Frame Report

Inspection Date: 8 Apr 2020

New Home Construction

Non Compliant 2.02

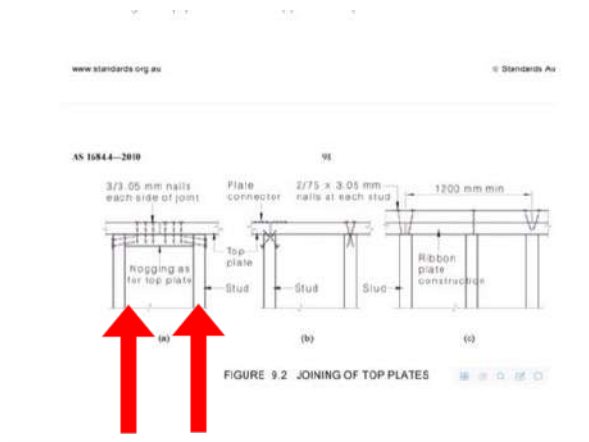
Finding: Joining of top plates /. Unsupported Top Plate Join On Double Plates.
It is a requirement of Australian Standard, A.S 1684 Residential Timber-Framed Construction, clause 2.4 Stud/Plate Lamination, that 'where joints occur in either top plate between studs, and where rafters or trusses bears onto top plates, additional blocking shall be provided (see Figure 2.9).'

The join in this top plate must be properly rectified in accordance with the above.

The connection between the top plates and the connections of the ribbon plates do not conform to As 1684.4 section 9.2.8 outlining the correct fixings and the distance between the joint of the top plate and the joint ribbon plate

Non Compliant 2.03

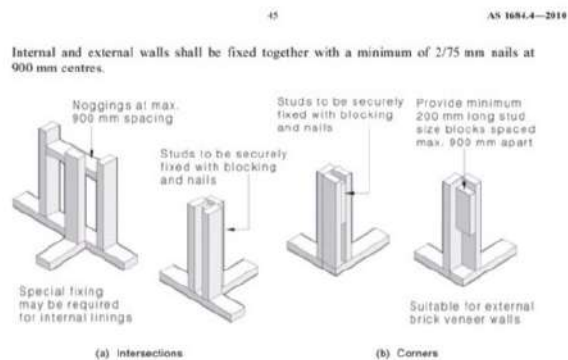
Finding: Blocking at intersecting walls - insufficient / undersized
 It was observed that the blocking of intersecting walls are insufficient in the nominated locations throughout the Structure.
 The AS1684.2 indicates that three blocks are required at intersecting walls (minimum length 200mm)
 At spacings not exceeding 900mm and each stud must be fixed to the block with 2/75mm nails.
 Where wall junctions are within a deemed wet area, blocks must be installed at a maximum of 600mm centres .

In particular the standard notes that all walls must be installed with noggings at a spacing not exceeding 1350mm and wall intersections don't negate this requirement.

Non Compliant 2.04

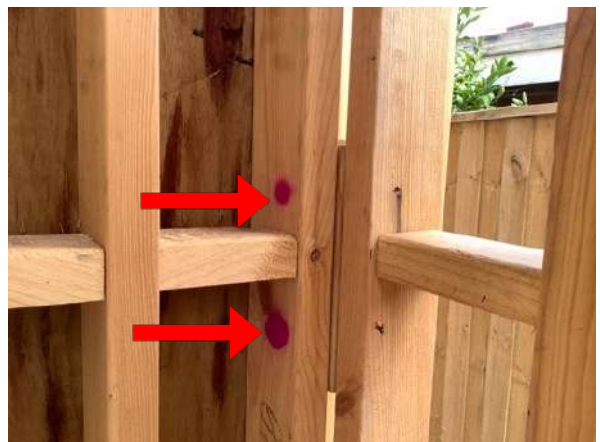
Finding: Blocking at intersecting walls - External as a minimum.

It appears none of the external walls on the dwelling have been nailed off. Section 9.5 and table 9.4 of AS1684.2. and section 6.2.1.3 of the same document states all connecting walls must be secured and nailed in accordance with both clauses.

The frame pass should not have been approved without this element being installed.

As a minimum the builder must nail off the external walls to ensure that the dwelling can resist the racking forces that AS 1684.2 mandates.

Non Compliant 2.05

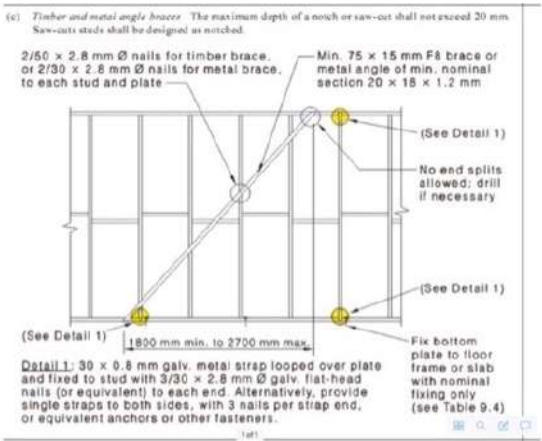
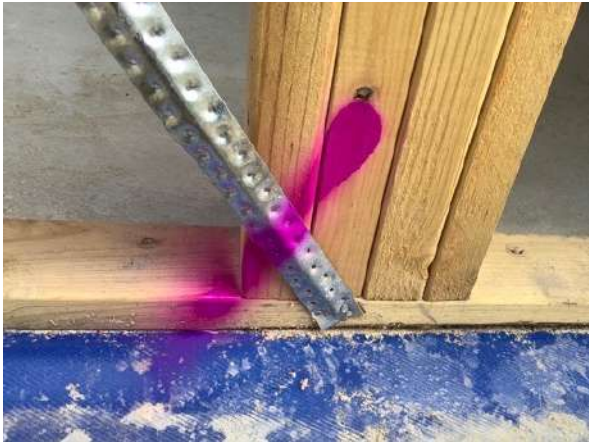
Finding: Bracing straps - not secured
It was identified that some bracing straps have not been secured correctly. The bracing straps are required to be secured with two galvanised clouts (2 x 30mm) to each stud and plate.

1. At the time of the inspection there were several bracing straps that were not secured correctly. AS 1684.2 clause 8.3.6.3 Structural wall bracing – see table 8.18 below

Non Compliant 2.06

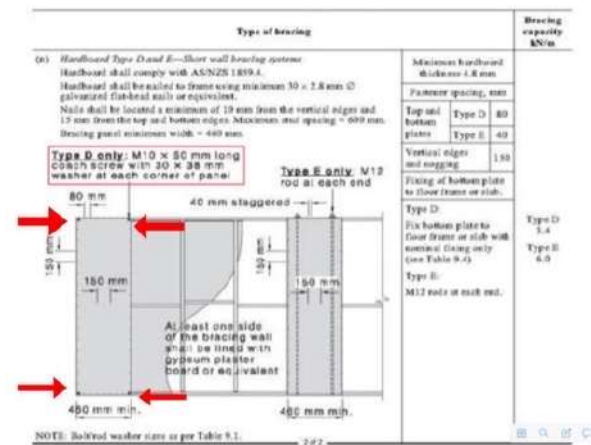
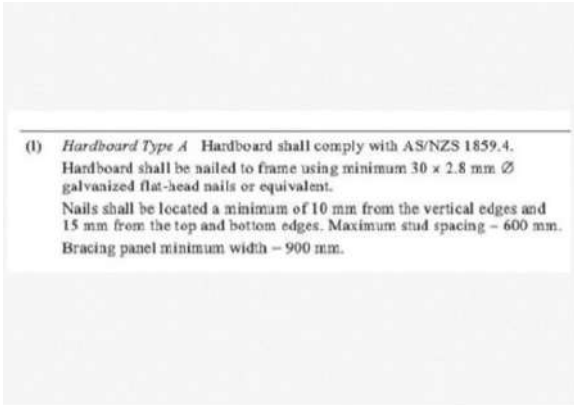
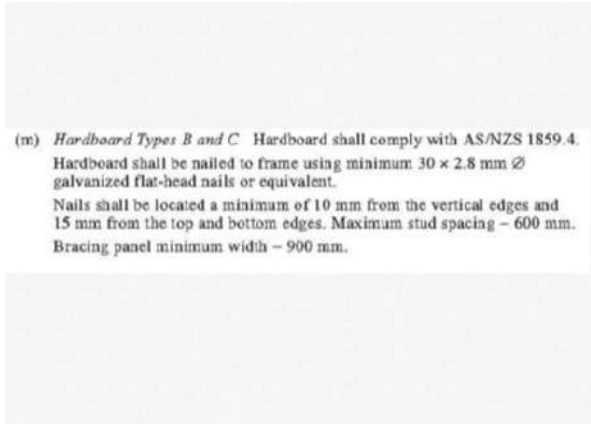
Finding: Bracing, 900mm or less, requires coach screws in each corner

1. As per the attached from the AS1684 standards the builder will need to install bolts or fasteners to all ply bracing that is less than 900 mm wide.

As per the AS1684 bracing guidelines any type 'D or E' short wall bracing below 900mm in width is required to be screw fixed at its outer most corners top and bottom with M10 x 50mm screws. Or alternatively two full lengths of M12 treaded vertical rods.

Type A, B or C bracing cannot be any less than 900mm in width, if the sheeting is less than 900mm then it is to be installed as type 'D & E' short wall bracing and has to be installed as per section (n) of table 8.18.

The builder will need to install the corner bolts (type D) or full length threaded rods (type E) as per the AS 1684 - (n) 8.18 requirements

Non Compliant 2.07

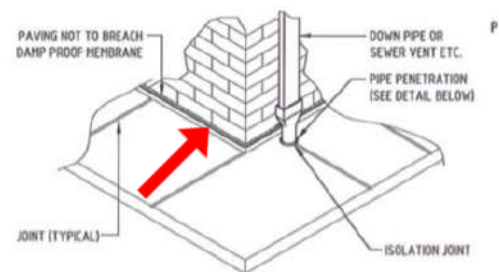
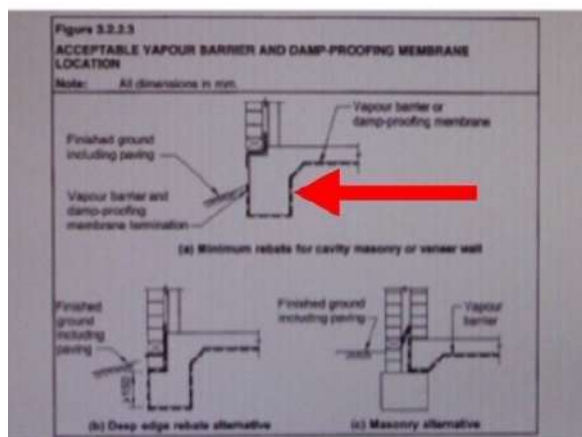
Finding: Vapour barrier - Defective (AS2870- 2011)

The functionality of the vapour barrier to the entire perimeter of the building including, between the the buildings each side of the house is being compromised due to poor workmanship during the installation/construction process.

It is a requirement of AS 2870-2011 5.3.3.4 that vapour barriers are turned up and terminated at ground level above pavement adjacent footing. The vapour barrier is defective if building materials and fill has been left on top of the membrane, as this prevents it from being pulled up against the slab when installing perimeter paving as it is intended to be.

This must be remedied immediately to prevent slab edge dampness.

For Your Information 5.13

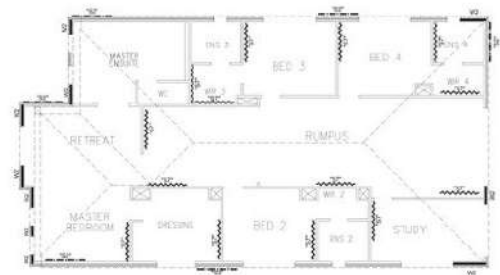
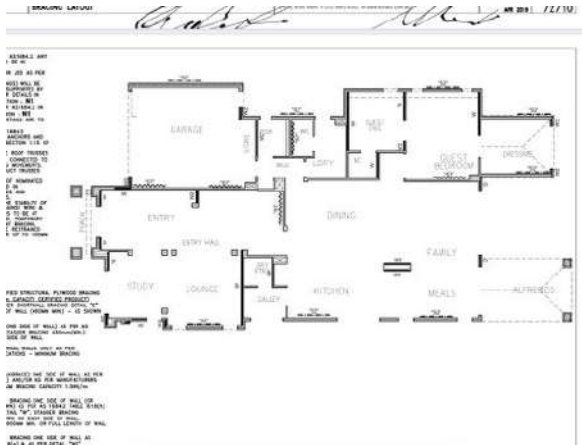
Finding: Shower Stud Width Acceptable
Additional photos are provided for your general reference.

Upon inspection of the shower areas, it appears that the stud width installation is at 300mm centres which is suspected to be adequate for shower areas as per BCA and the framing standard.
